ADDENDUM TO FEASIBILITY STUDY AND INTERIM ACTION  
WORK PLAN

8801 E Marginal Way South

TUKWILA, WASHINGTON

Agreed Order No. 6069

FIG. 4

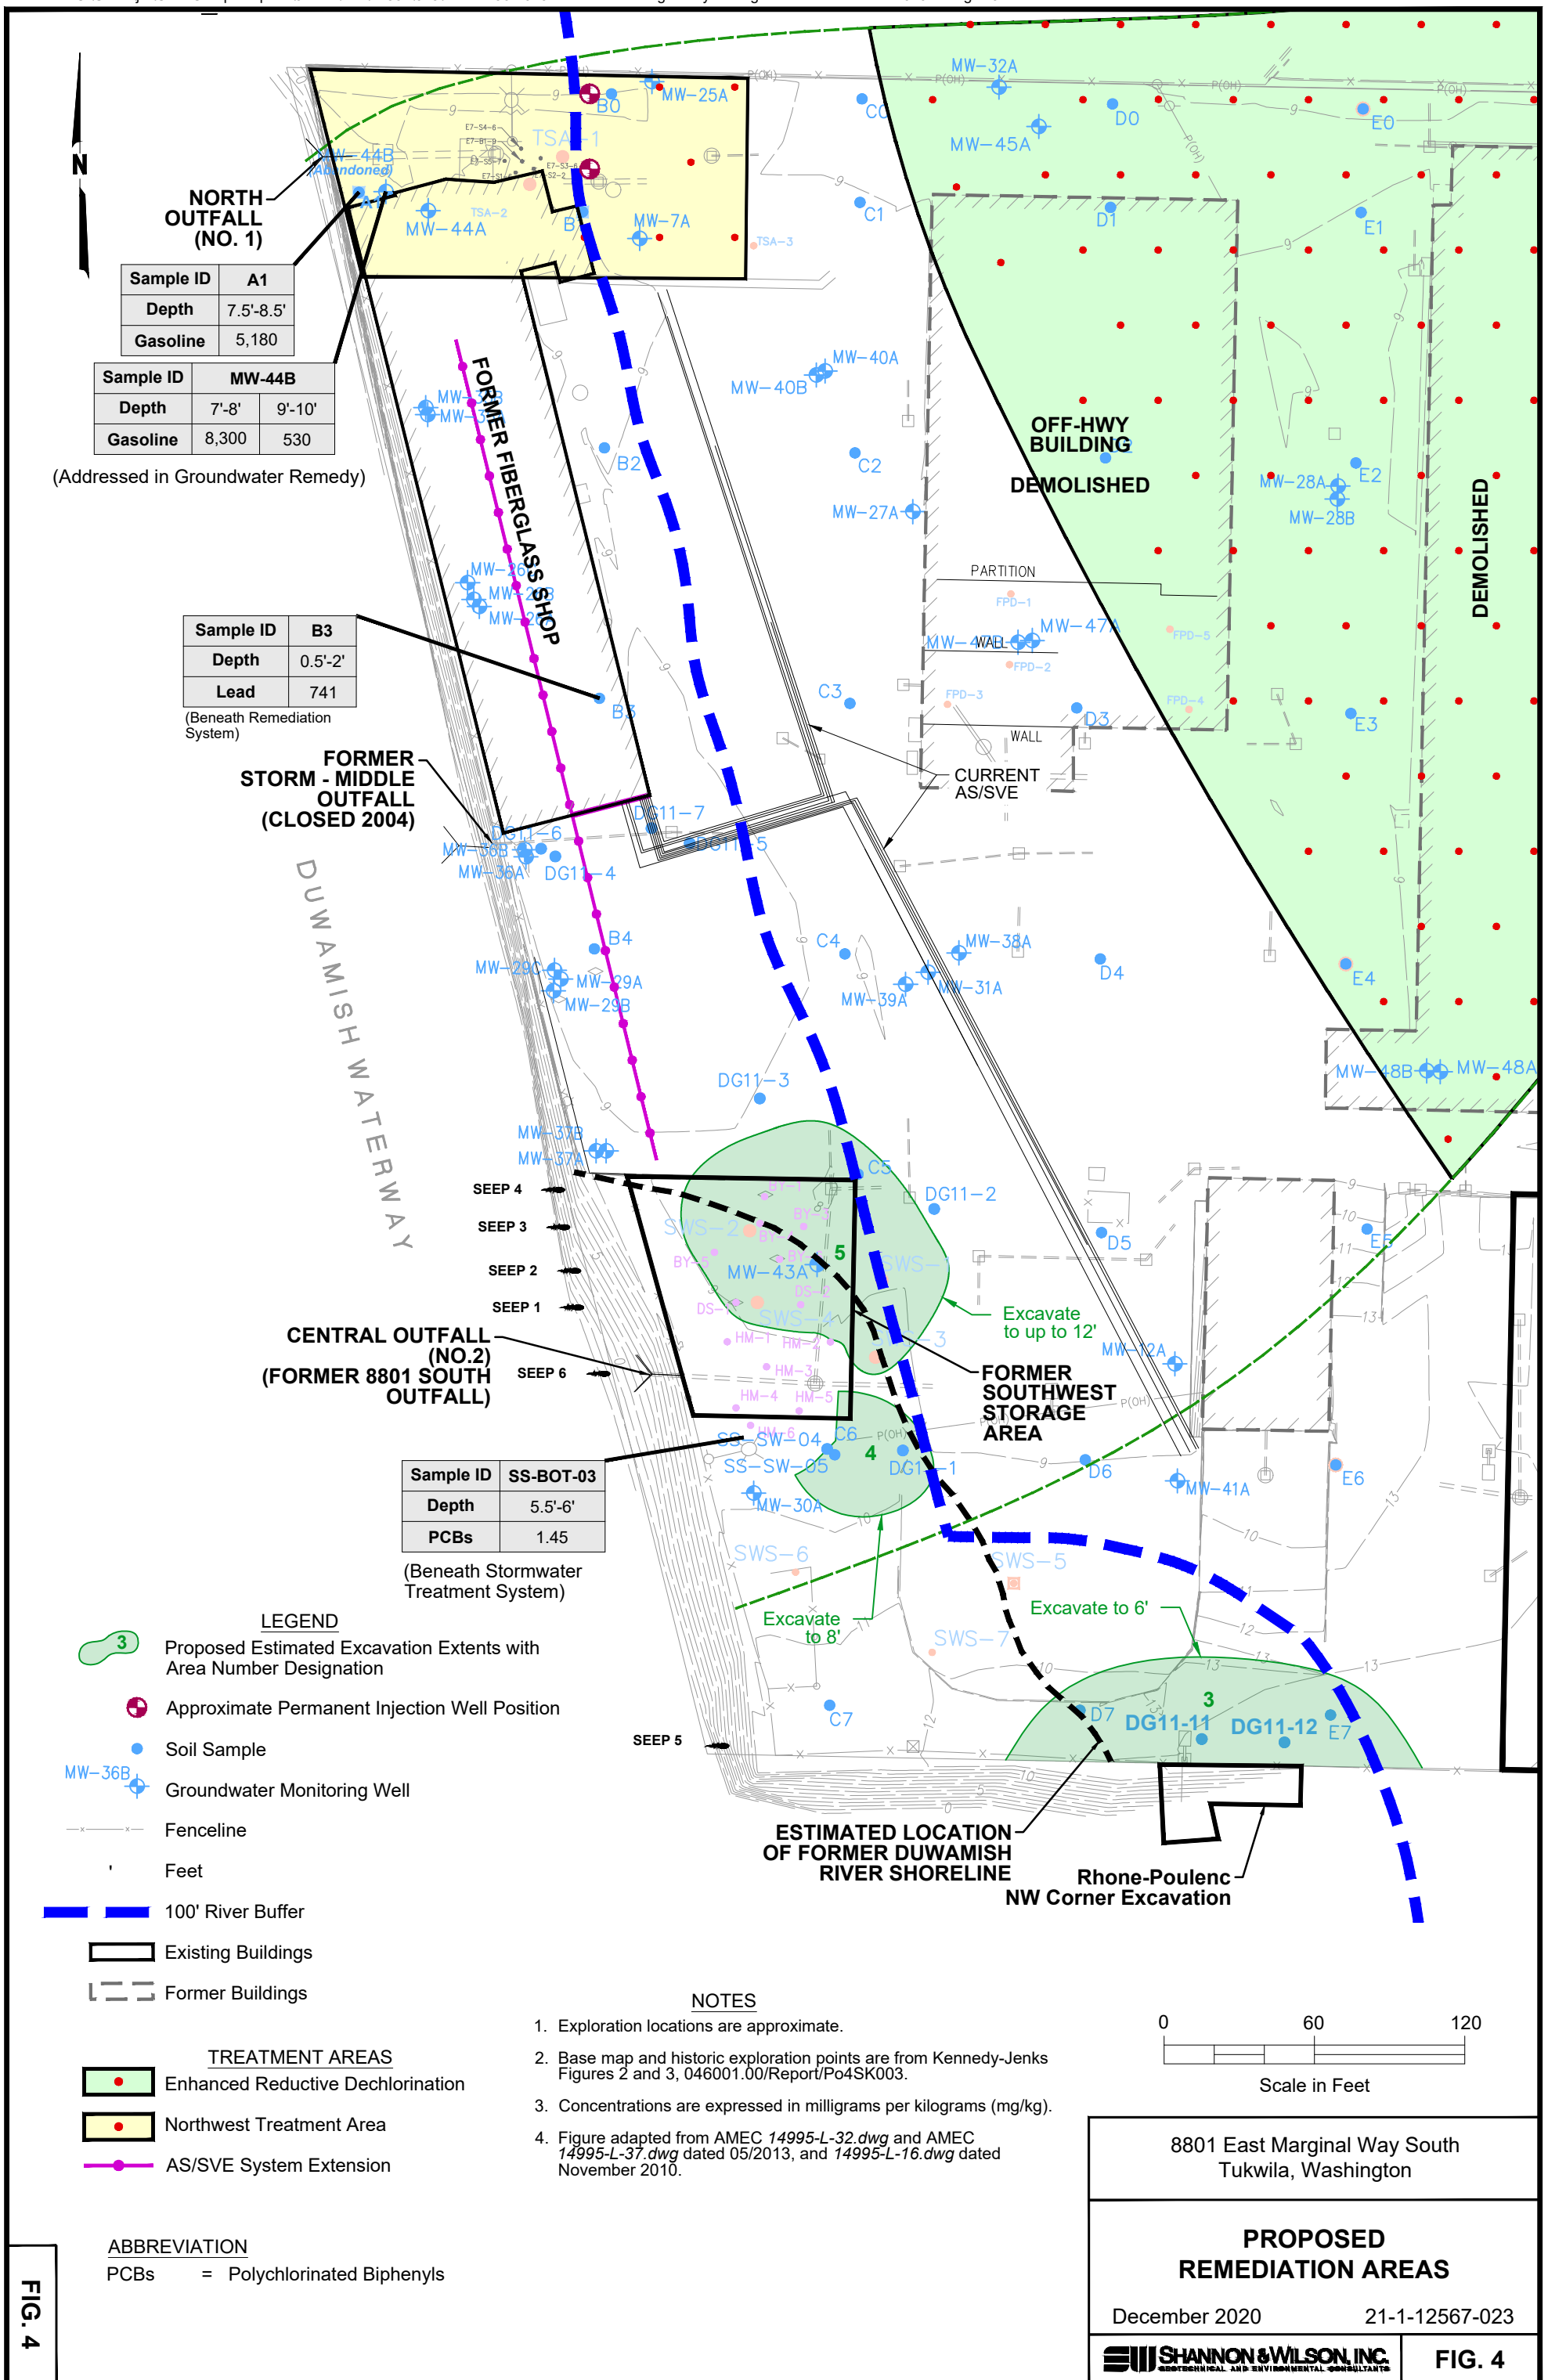
This section describes the COCs above the RELs in soil within the 100-foot river buffer. Soil contamination above the REL exists in four hotspot locations along the shoreline. These four hotspot locations are identified in the FS as E7 and Vicinity (Area 3), DG11-1 and Vicinity (Area 4), the Southwest Storage Area (Area 5), and the Northwest Area (Area 8). Soil contamination above the REL also exists in two samples along the shoreline, but are unsuitable for immediate remediation (Figure 4), including:

The three hotspot areas where COCs exceed the soil RELs in the 100-foot river buffer portion of the shoreline area will be removed. The hotspots to be excavated include the same three hotspots identified in Alternative 2 (Figure 4).
